VIRGINIA ELECTRIC AND POWER COMPANY
RICHMOND VIRGINIA 23261

Serial No. 92-662
NL&P/MAE: R4
Docket No. 50-338
License No. NPF-4

VIRGINIA ELECTRIC AND POWER COMPANY
NORTH ANNA POWER STATION UNIT 1
TEMPORARY WAIVER OF COMPLIANCE
TURBINE THROTTLE VALVES 1 AND 3

ATTACHMENT 1
NORTH ANNA UNIT #1
STEAM CHEST ARRANGEMENT

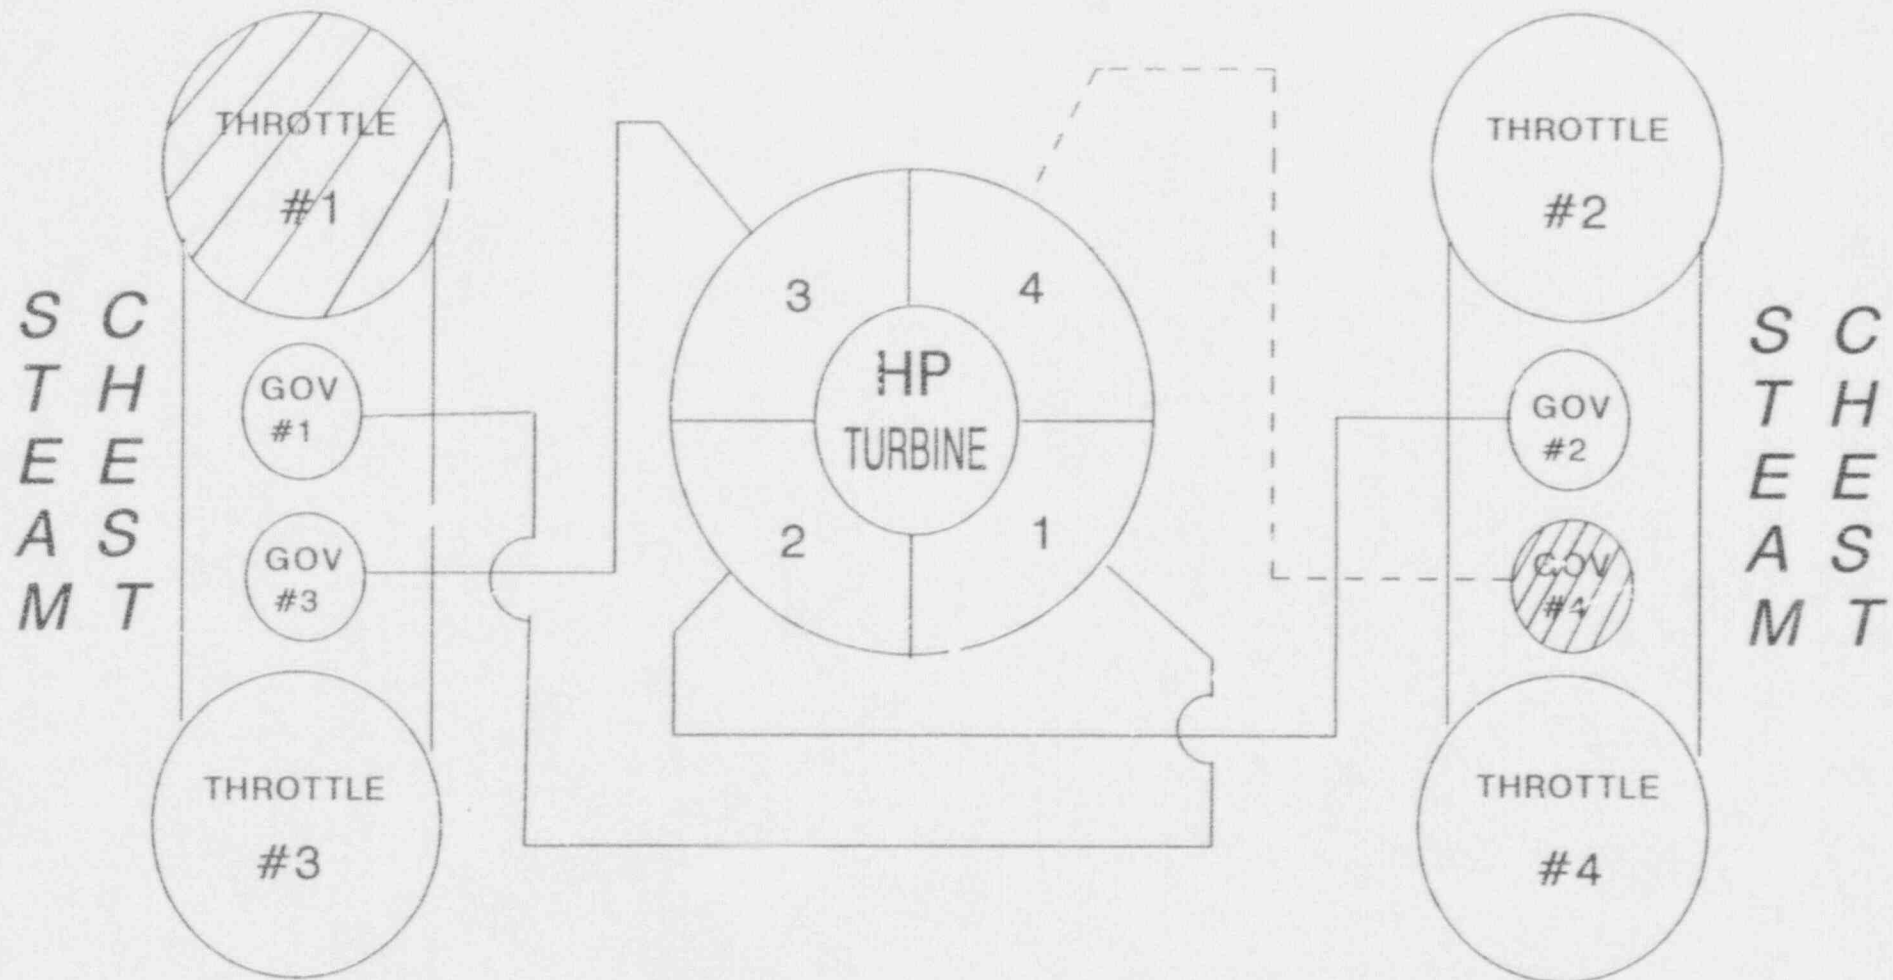
The steam supplied to the high pressure turbine is controlled by four throttle valves (or stop valves) and four governor valves as shown in Attachment 1. The actuator stem on throttle valve 1 recently failed. The valve failed closed, which is the safe position, and is clamped to ensure it remains closed. The actuator stem connects the throttle valve disc to the actuator. The purpose of the turbine throttle valves is to provide turbine overspeed protection. These valves receive a close signal on turbine trip. It is not desirable at this time to repair the valve due to possible personnel safety concerns and an increased potential to induce plant transients. The turbine manufacturer (Westinghouse) has recommended that throttle valve 3 not be cycled as required by surveillance requirements 4.7.1.7.2.a & b because closing this valve would cut off all steam to the steam chest associated with governor valves 1 and 3. This would isolate nozzle chambers 1 and 3 on the high pressure turbine. Nozzle chamber 4 is already isolated as a result of the closure of governor valve 4, due to the normal coastdown process. The closure of throttle valve 3 would cause the first stage blades of the high pressure turbine to exceed design conditions.

The PRA has been further revised to reflect throttle valve 1 as closed, and not cycling throttle valve 3 and the four governor valves for the duration of the Unit 1 coastdown. The results of the PRA determined the probability of a turbine missile ejection as $1.9\text{E-}06$. This is acceptable under the NRC guidelines which allow the turbine to be loaded and brought on line with a probability of less than $1.0\text{E-}05$. The reliability of the throttle valves is high. A review of the surveillance testing records for the last nine years showed that none of the throttle valves have failed to perform their required function during surveillance testing.
